Access Compliance Report

Public Rights-of-Way

(Pedestrian Signals)

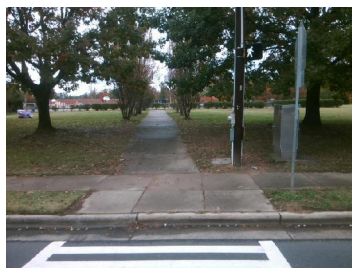
PROW/ADA: R209.1, TMUTCD 4e.08, R404.7.3, MUTCD 4e.10

Yes B 1 Clear Xing Direction?	ClearlyMarked	N/A B 2 Clear Xing Direction?	N/A
B 1 Crossing Direction	To S	B 2 Crossing Direction	N/A
Yes B 1 DistanceTo XWalk (in)	19.0	N/A B 2 DistanceTo XWalk (in)	N/A
No B 1 DistanceTo Curb (in)	135.0	N/A B 2 DistanceTo Curb (in)	N/A
Yes B 1 Diameter (in)	2.0	N/A B 2 Diameter (in)	N/A

Possible Solutions: Replace Signal Push Button With APS Button on New Post.
